Access Compliance Report

Public Rights-of-Way

Intersection ID: 27426	Main Street: MEADOW_RUN_LN	Cross Street: SUNINGHURST_LN	Location: S
ADA ID: A82A6FAE276F	Ramp Type: BlendTrans2	Initial Pass/Fail: Fail	Overall Compliance: No
Severity Score: 21.25			
Codes/Mitigation Info/Possible Solution		Field Measurements/Component Compliance

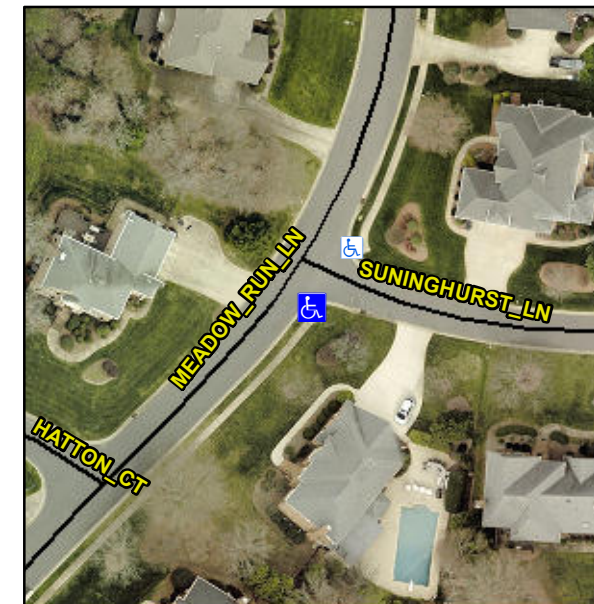
Compliance	Description	Data	Compliance	Description	Data
N/A	Ramp Length (in)	93.0	Yes	BlendTrans Slope (%)	3.5
No	Ramp Width (in)	47.0	No	BlendTrans XSlope (%)	6.5
N/A	Flare Type LT	N/A	N/A	Flare Type RT	N/A
N/A	Flare Slope LT (%)	N/A	N/A	Flare Slope RT (%)	N/A
N/A	Flare Traversable LT?	N/A	N/A	Flare Traversable RT?	N/A
N/A	Landing Length (in)	N/A	N/A	DWS Provided?	N/A
N/A	Landing Width (in)	N/A	N/A	DWS Contrast?	N/A
N/A	Landing Slope (%)	N/A	N/A	DWS Length (in)	N/A
N/A	Landing X Slope (%)	N/A	N/A	DWS Full Width?	N/A
N/A	Landing Curb? (Y/N)	N/A	N/A	DWS Offset (in)	N/A
N/A	Shared Landing?	N/A			
N/A	Gutter Ponding?	N/A	N/A	Gutter Slope (%)	N/A
N/A	Gutter Lip Ht (in)	N/A	N/A	Gutter X Slope (%)	N/A
N/A	Painted X Walk1?	No	N/A	Painted X Walk2?	No
	X Walk 1 Direction	To NE		X Walk 2 Direction	To NW
	X Walk 1 Width (in)	N/A		X Walk 2 Width (in)	N/A
	X Walk 1 Slope (%)	3.4		X Walk 2 Slope (%)	1.5
	X Walk 1 X Slope (%)	4.5		X Walk 2 X Slope (%)	4.3

N/A	Ramp inside XWalk1?	N/A	N/A	Ramp inside XWalk2?	N/A
	Road Slope (%)	6.1		Clear Space?	N/A
	Road X Slope (%)	0.3	N/A	Clear Space to XWalk (in)	N/A
N/A	Any Obstructions?	N/A	N/A	Storm Grate/Utility Hazard?	N/A
	Obstruction Type			Storm Grate/Utility Type	
		N/A			N/A
			Yes	Surface Condition? (G/P)	Good
			N/A	Curb Slope (%)	0.9

Remove & Replace Curb Ramp With Two New Directional Ramps or Equivalent.
